**TOWN OF DELAFIELD PLAN COMMISSION MEETING**  
**Tuesday, March 5, 6:30 p.m.**  
**Town of Delafield Town Hall W302 N1254 Maple Avenue, Delafield, WI 53018**  
**Amended 3/1/2024@9:00AM**

# Plan Commission Report for March 5, 2022

Requested Action: Approval of site, grading/drainage, landscaping, lighting, architectural plans, and plan of operation

SITE PLAN C1.0

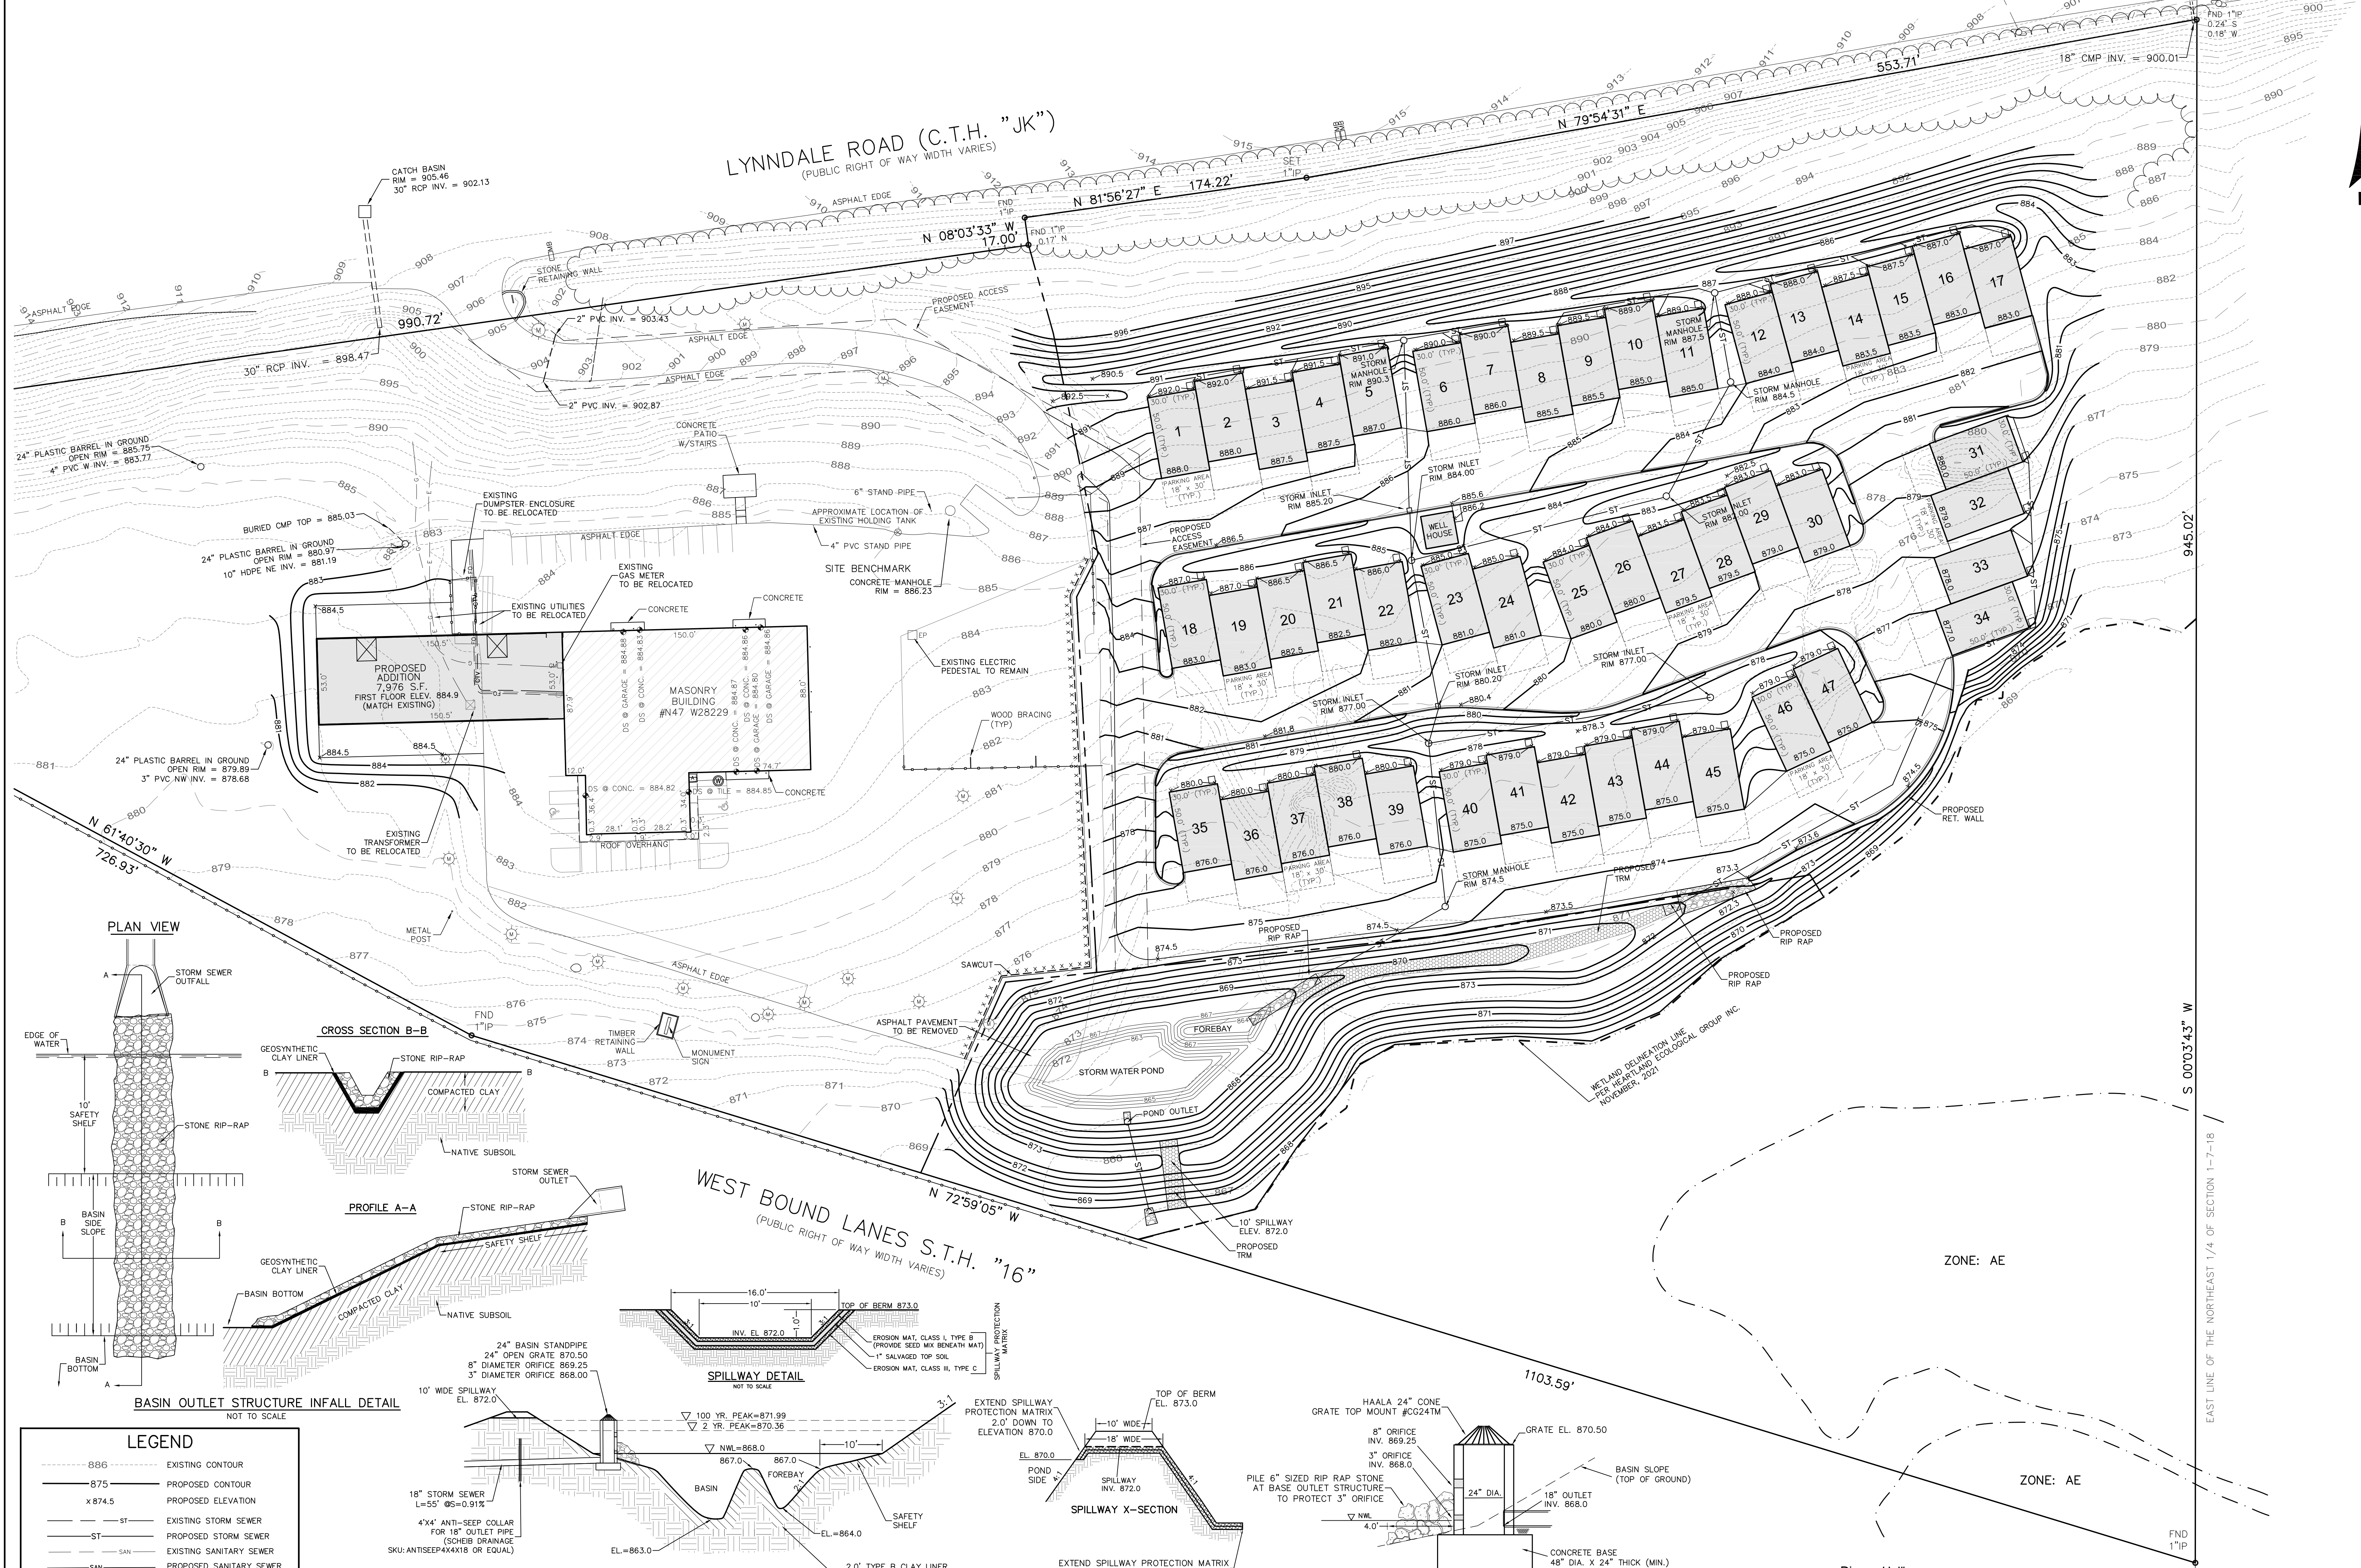
The buildings will be in clusters of 2 to 6 side-by-side units. The doors to the buildings will be oriented to the south and west. Access to the site will be via the existing driveway off of CTH JK. Waukesha County has indicated that no improvements are required on CTH JK and that a shared use driveway is acceptable. A shared driveway easement agreement has been recorded. The access easement is shown on the site plan. Access to each unit will be via paved drives. There is an 18' x 30' asphalt parking area in the front of each unit. Aisle widths between the noted parking area and edge of curb is 20.8 feet (minimum) and 24.5 feet typical. A fire truck access movement plan dated 6/14/22 was submitted indicating that a Pierce Arrow XT fire truck (information provided by Lake Country Fire Department) can make all turning movements throughout the site.

I recommend approval of the following plans subject to the plans being updated to match the layout on the Toy Box Condominium plat and to remove the designation of outside air conditioning units:

- Site Plan and Site Grading Plan (as it relates to Lake County Toy Box) prepared by CJ Engineering dated 11/3/22.
- Fire Access Exhibit (as it relates to Lake County Toy Box) prepared by CJ Engineering dated 6/14/2022.
- Landscape Plan (as it relates to Lake County Toy Box) prepared by InSite Landscape Design dated 7/12/22.
- Lighting Plan (as it relates to Lake County Toy Box) prepared by InSite Landscape Design dated 7/12/22.
- Architectural Plans (as it relates to Lake County Toy Box) prepared by Galbraith, Carnahan Architects, LLC dated 7/12/22.

SITE GRADING PLAN C2.0

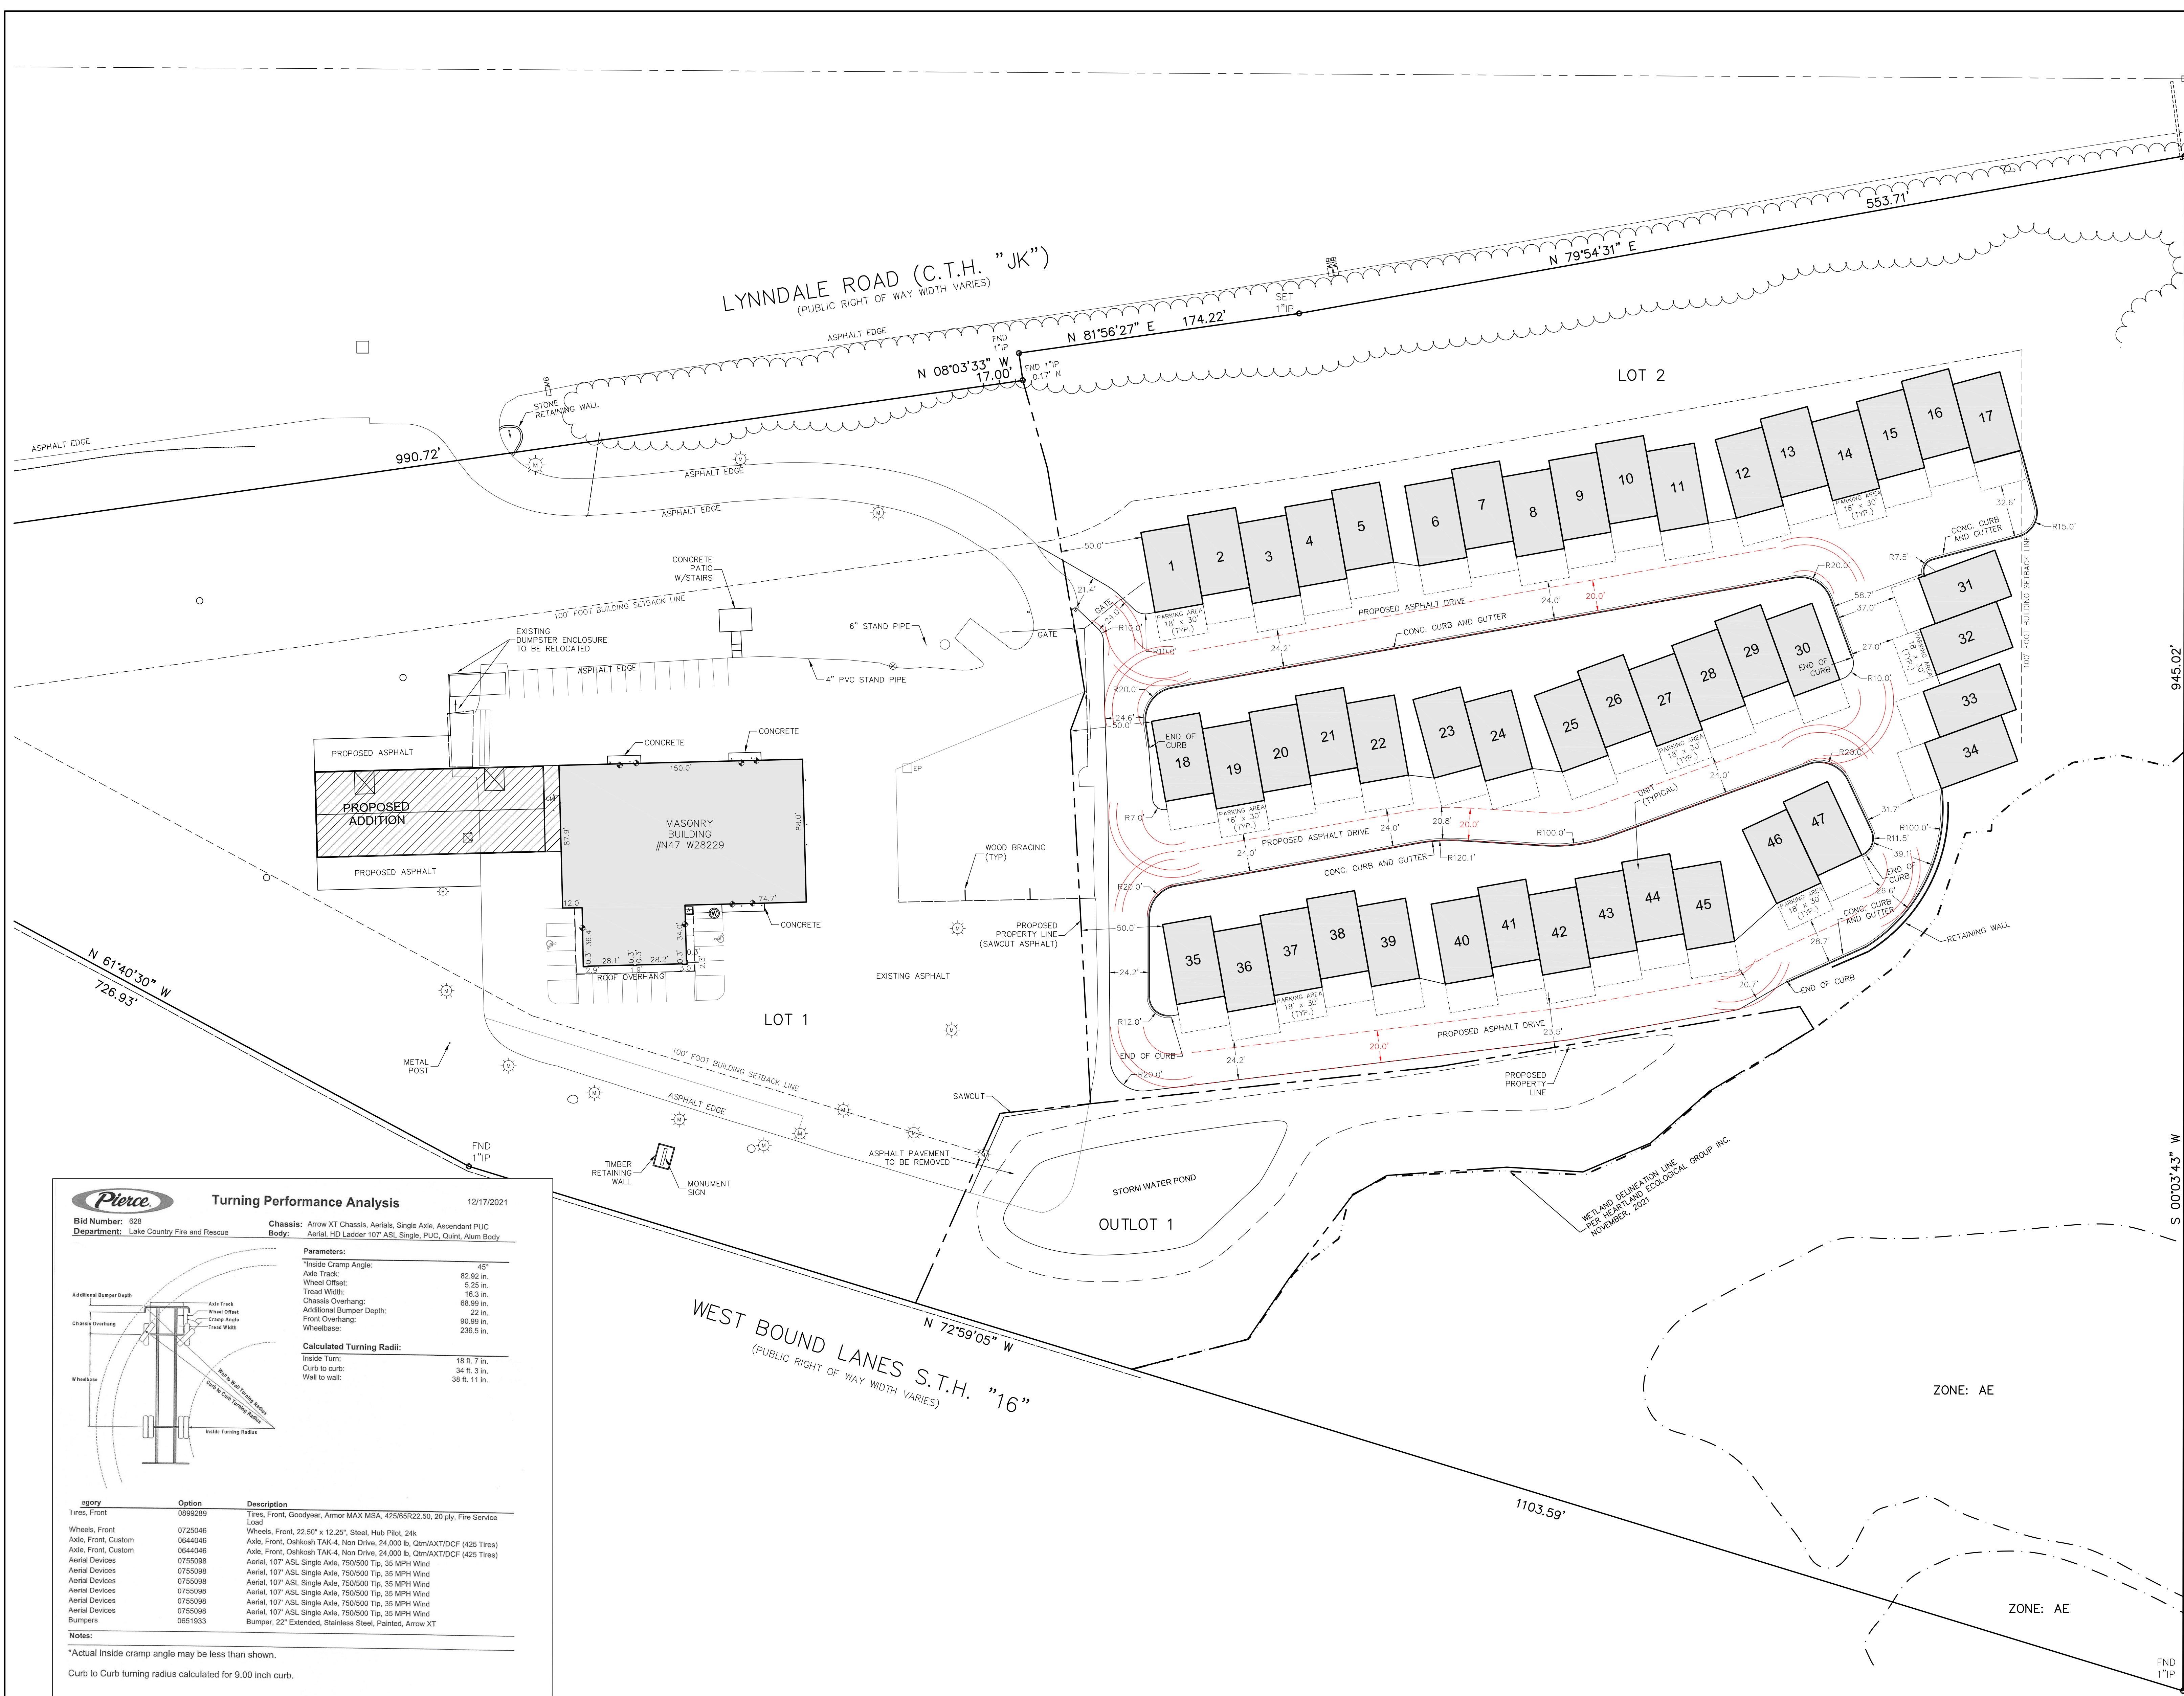
The existing grade on the site drops from the north to the south by approximately 26 feet in the area being disturbed for the buildings and approximately 7 feet from west to east. The building elevations will step down to the south and to the east to match the existing topography. All aisles will be paved and the southerly extent of the aisle will be curbed to capture the water flow and direct it to a storm sewer system. The storm sewer system will eventually discharge into a stormwater pond proposed for an outlot located south of the lot. Waukesha County reviews the stormwater management plan and has not received the information necessary to perform a complete review of the stormwater management for the site.
